CITY PLAN COMMISSION STAFF REPORT

Project Name
Emmanuel Science and Technology Center

Request
CD-CPC-2025-00037
Area Plan Amendment
CD-CPC-2025-00008
Rezoning without Plan
CD-CPC-2025-00004
Development Plan – Nonresidential

Project: Emmanuel Science and Technology Center

Site Plan

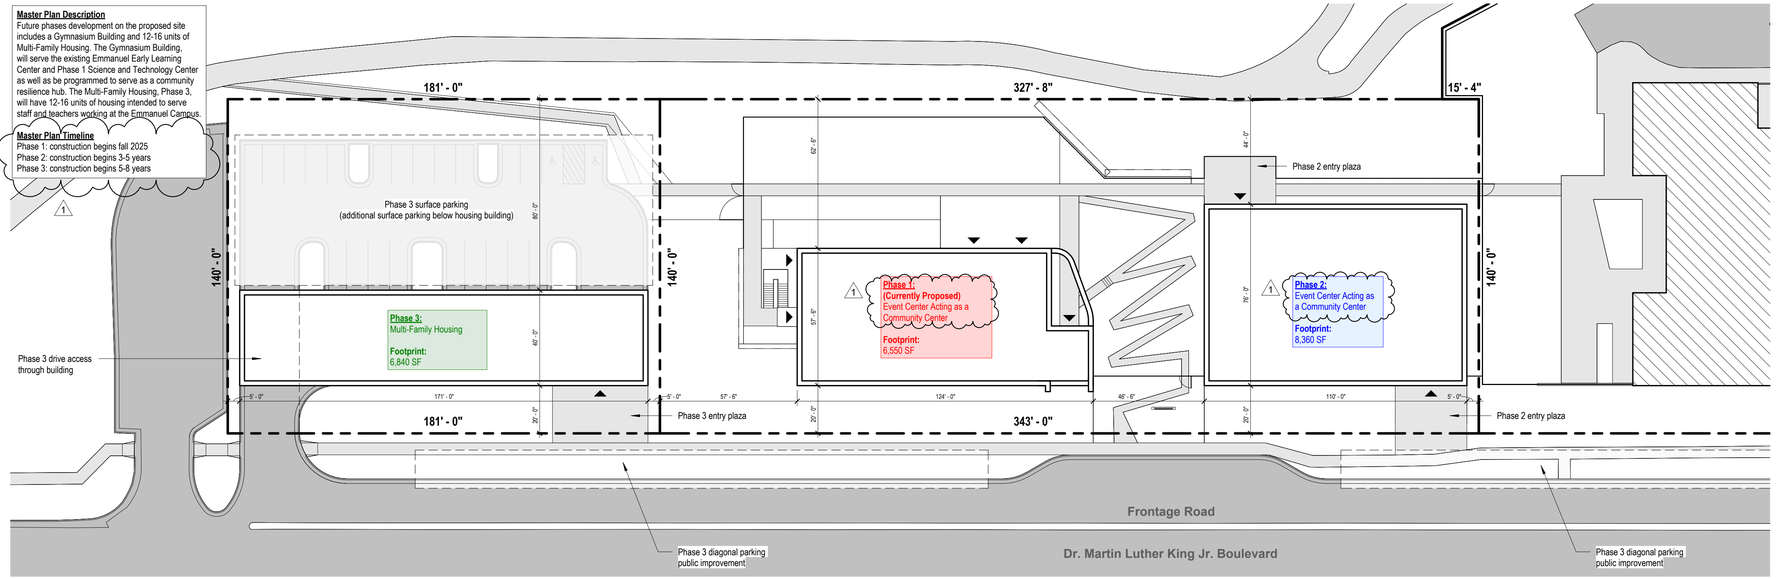
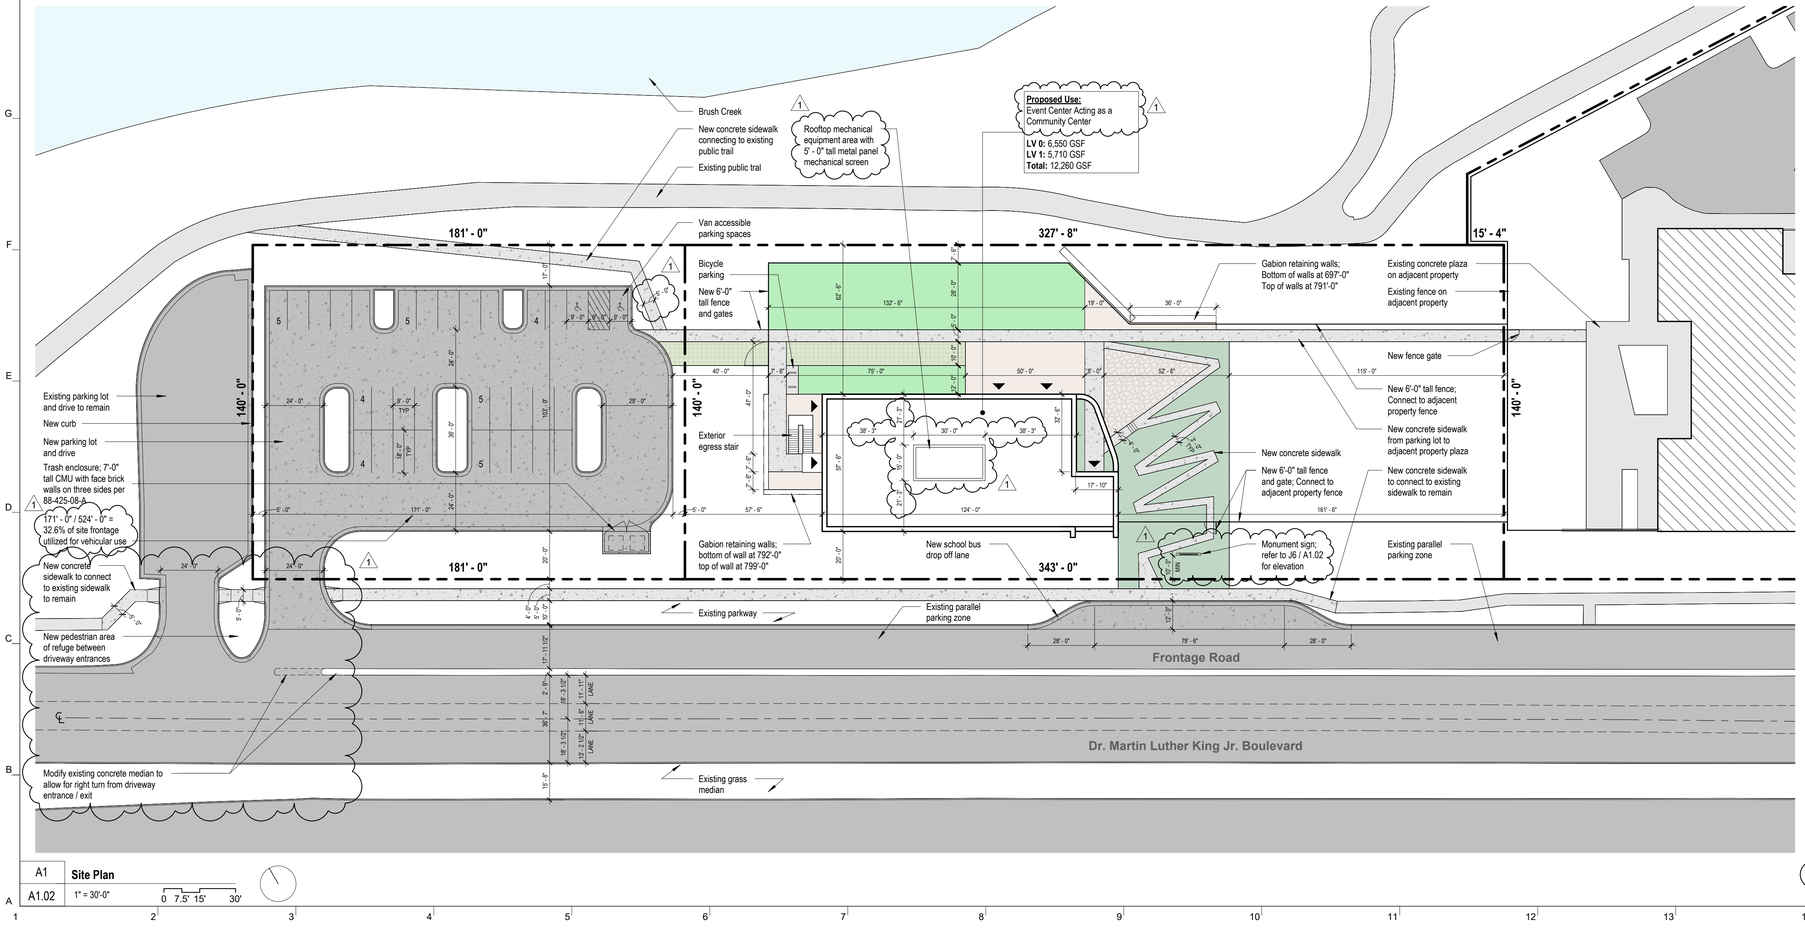
Variance 1 – A variance to 88-323-02-B (1) – If adjacent to and within 150 feet of a boulevard or within a development node, a vehicular use area must be located on the side or rear of the building. Parking located on the side of the building shall be set back a minimum of 10 feet behind the front building line or 30 feet from the right-of-way, whichever is greater.

Variance 2 – A variance to 88-323-02-B (3) – No more than 30% of a site's frontage adjacent to the boulevard or parkway may be used for vehicular use areas.

The applicant is proposing one new access point to their proposed parking lot from the frontage road on the western end of the subject site. The proposed plan shows the new access adjacent to the existing driveway to the Parks Department owned parking lot; the two driveways are also located at at the intersection of the frontage road with Dr Martin Luther King Jr Boulevard. The proposed plan shows the existing median separating the frontage road from the boulevard being shortened in conjunction with a widened pedestrian refuge area between the two driveways. Public Works and Parks have both reviewed these changes to the frontage road and driveway access.

Include on the site plan a pedestrian connection from the parking lot to the sidewalk along MLK Blvd.

24. The developer shall continue working with city staff regarding the driveway entrances to both parking lots located at the western portion of the development.

J1 **Building-Mounted Wall Sign**
A1.02 1/2" = 1'-0" (0 6" 1' 2')

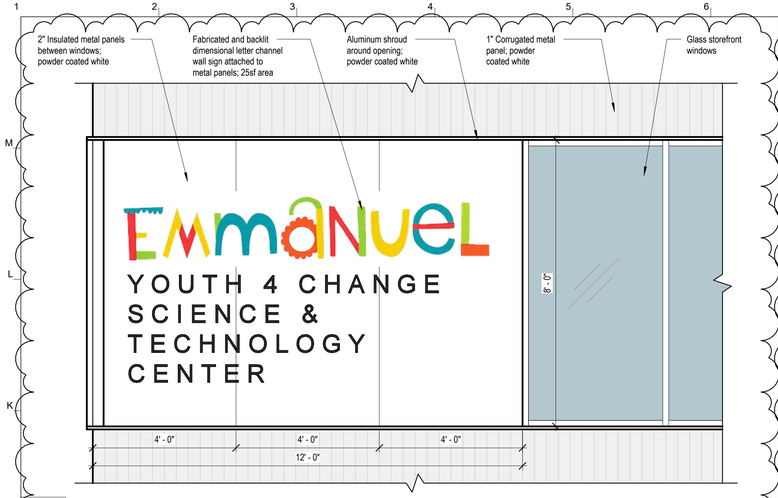
Variance 5 – A variance to 88-445-07 – A wall sign shall not exceed 50 square feet.

6. All signage shall conform to 88-445 and shall require a sign permit prior to installation.
7. That prior to recording the Final Plat the developer shall upload and secure approval of a Street Tree Planting Plan from the City Forester.

E6 **Building Elevation at South Facade**
1" = 10'-0" (0 2.5' 5' 10')

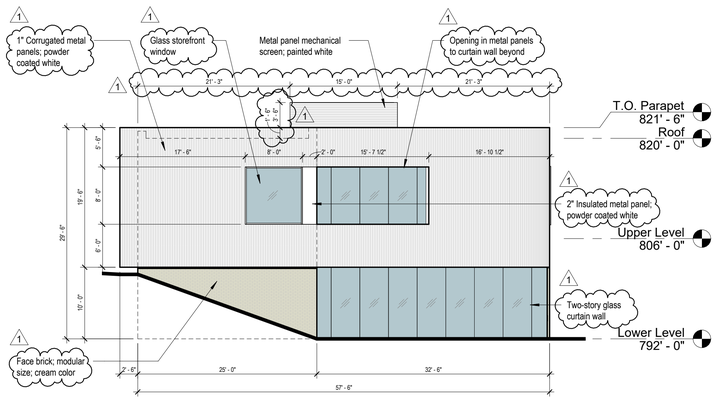
Variance 3 – A variance to 88-323-02-E (6) – If adjacent to and within 150 feet of a parkway, structures shall provide a minimum of 33% transparency on the ground level façade facing the parkway.

4. That all lots and structures along the parkway shall meet the parkway standards (88-323).
5. That the developer receives approval of the required variances from the Board of Zoning Adjustment or revise plans to show compliance with the Zoning and Development Code.

LANDSCAPE PLAN

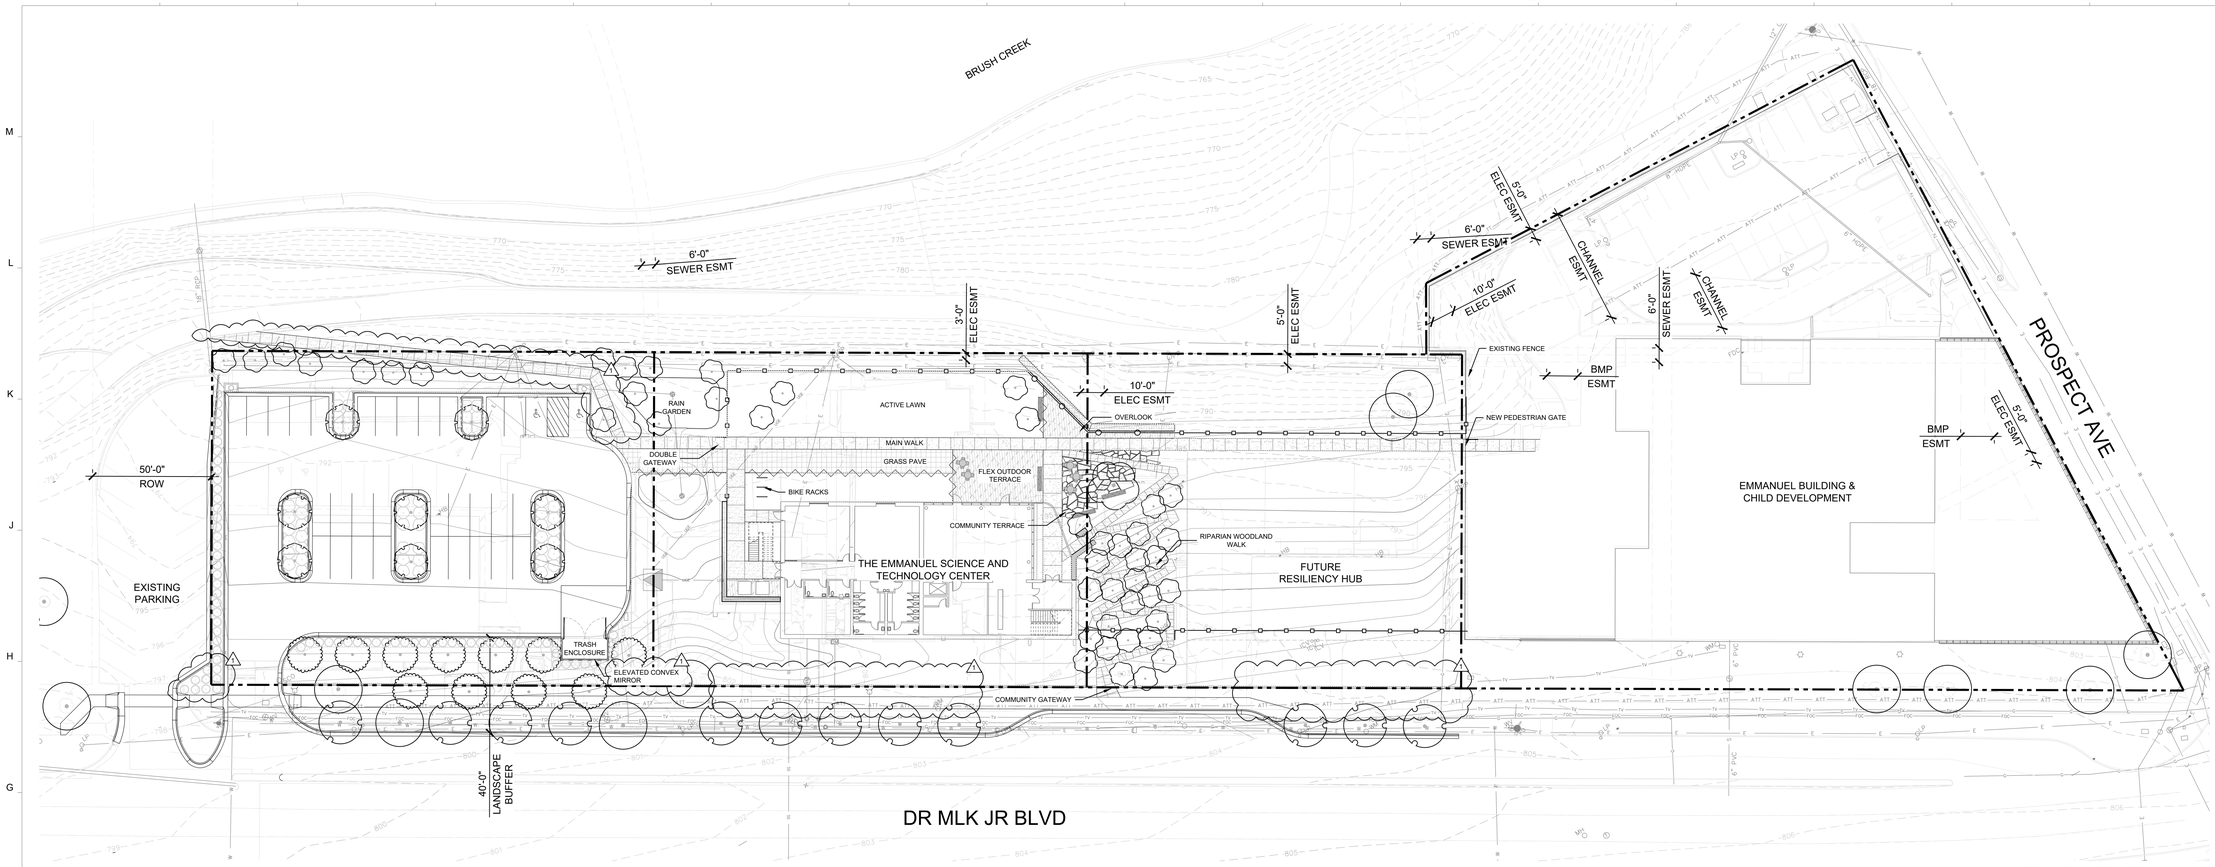
Variance 4 – A variance to 88-425-03-C. (1) – At least one street tree is required for each 30 feet of street frontage.

Proposed landscaping is currently not in conformance with the requirements as set forth in Section 88-425 of the Zoning and Development Code. The applicant will seek a variance to the required amount of street trees or revise plans prior to ordinance request.

1. That prior to issuance of the Certificate of Occupancy for each lot within the plat the developer shall submit an affidavit, completed by a landscape architect licensed in the State of Missouri, verifying that street trees have been installed in accordance with the approved Street Tree Planting Plan and are healthy.
